KARACHI MUNICIPAL CORPORATION.

ORDER UNDER SECTION 96 (2) OF ACT, III OF 1901.

With reference to his application dated 3rd December 1926 requesting permission to build on plot No: 44 Sheet A-12 Machi Miani quarter in accordance with plan No: 166 approved by the Engineer Karachi Municipality Mr. Chagla Wali Mohamed is informed that the permission applied for is granted provided he obtains permission of the Karachi Municipality before commencing the work.

ON. S. No 44A-12 MACHIMEANI Qd

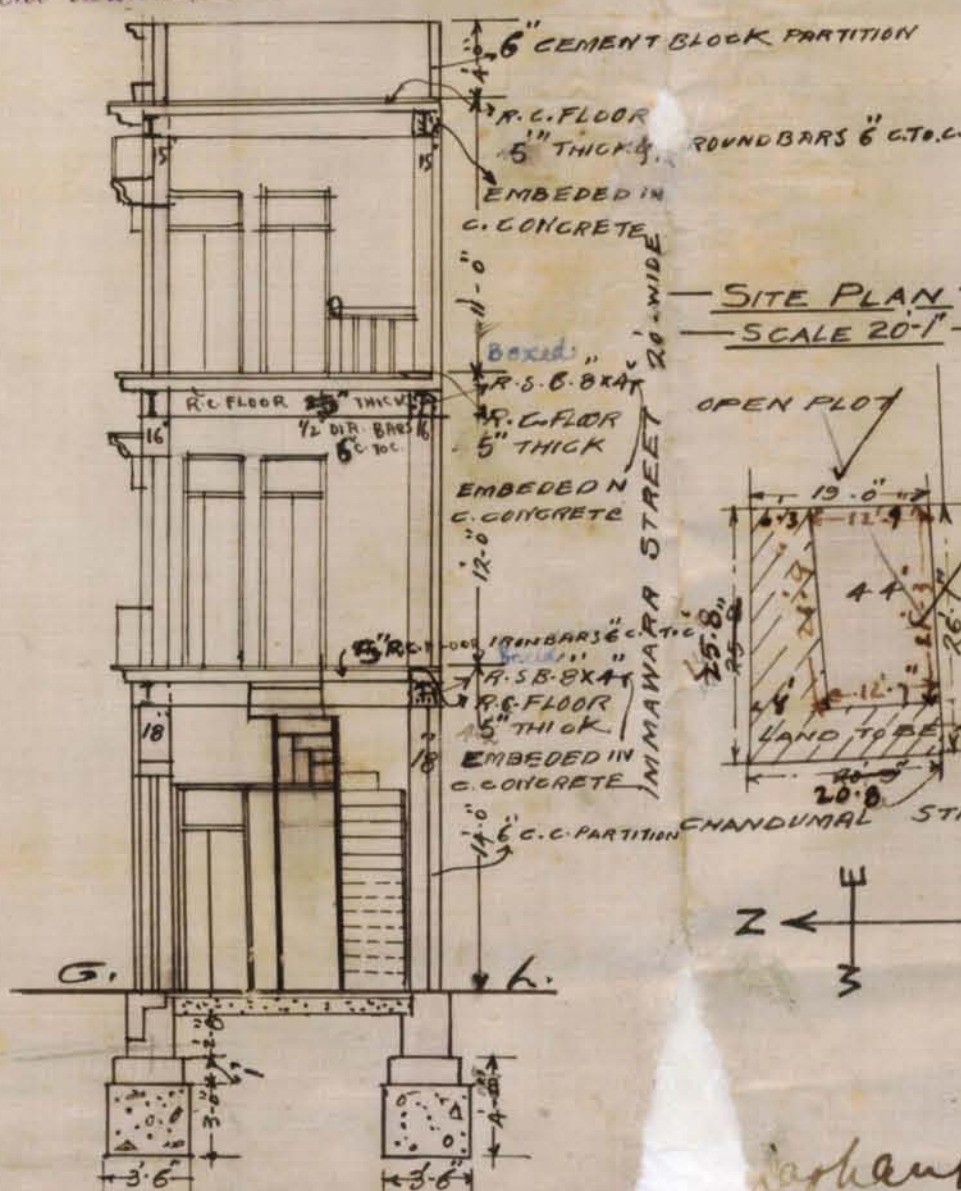
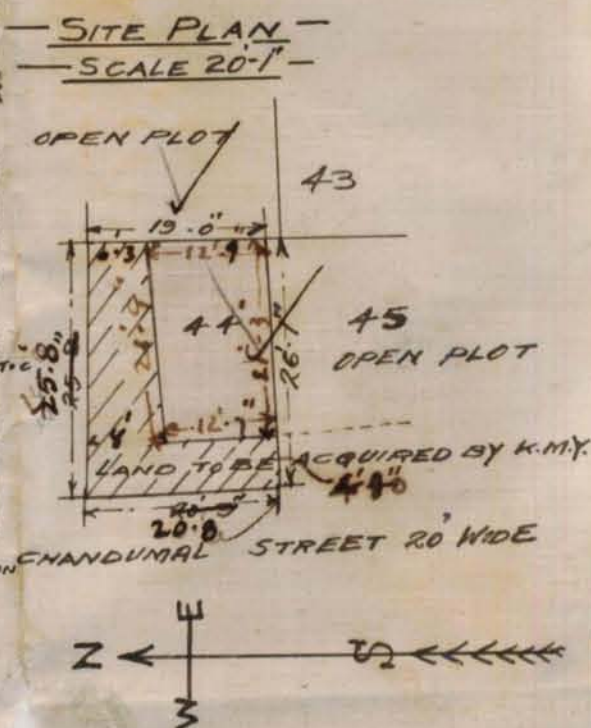
- (1) Title deed to be produced
- (2) Details of Stair-case must be shown on plan.
- (3) 12" Lintels with 4 rods 1" diameter to run over each of the 6" wall.
- (4) Beam A must be. 14" x 8" with 4 rods 1" diameter
- (5)
- (6)
- (7)
- (8)
- (9)

- (1) Title deed to be produced
- (2) Details of Stair-case must be shown on plan.
- (3) 12" Lintels with 4 rods & 1" diameter
- (4) must run over each of the 6" wall.
- (5) Beam & must be 14x18" with 4 rods & 1" diameter.
- (6)
- (7)
- (8)
- (9)

(2) Details of stair-case. viz. posts, etc. must be shown on plan.

(3) Pillar, at the crossing of each partition walls, is necessary. at every place.

Sir,
With reference to your personal
interview on the 22nd inst I have
the honour to send you herewith
amended plan of S.No. 44, A-12, Mian
mian Quarter making changes in
the plan as suggested by you & hope
you will be kind enough to approve
the same at an early date.
I have the honour to

A Beans 14 x 8
with glass? 2.

— PLAN SHOWING PROPOSED HOUSE TO BE —

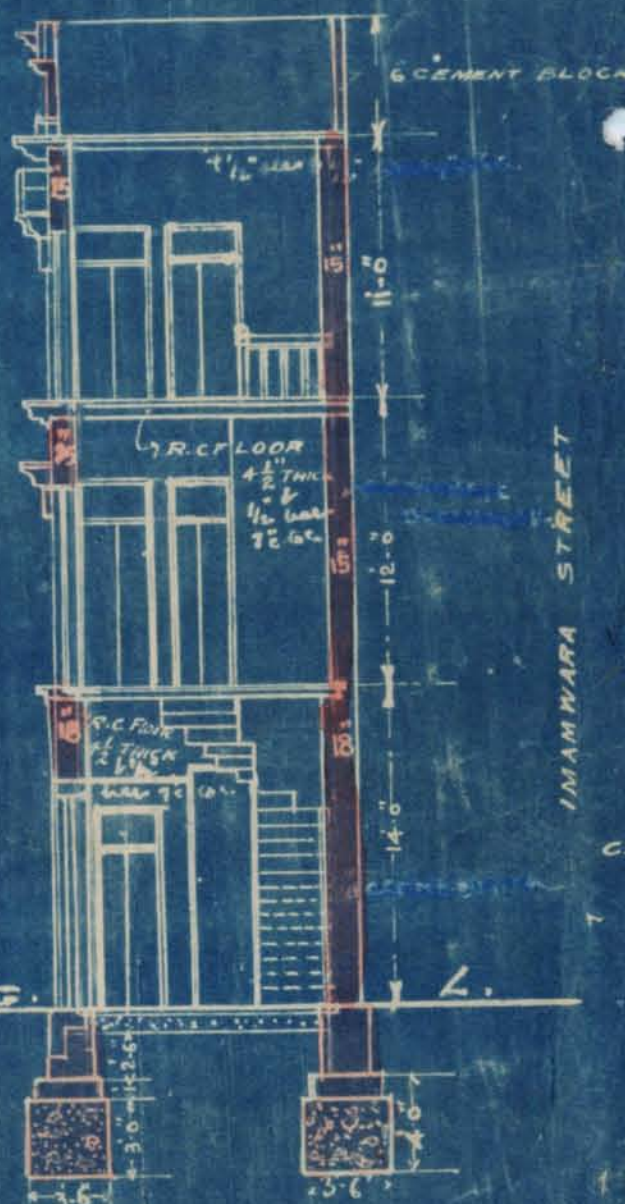
- (1) There should be separate passage for this W.C. The passage is through
- (2) the bath at present.
- (3) Wall of Gr. floor must be at least 18" thick and 1st floor 15"
- (4) Plan & Cross-section should be fully
- (5) dimensioned
- (6)
- (7)
- (8)
- (9)

There should be separate passage for the W.C.
The passage is through the wall at present.

(1) The plan & C.S. should be fully
dimensioned(1) wall of 1st floor should be atleast 18" thick
and 1st floor 15"

- (1) Separate passage to w.c. is shown on plan.
- (2) Wall of ground floor & first floor are made 18" & 15" thick respectively.
- (3) The cross section is fully dimensioned.
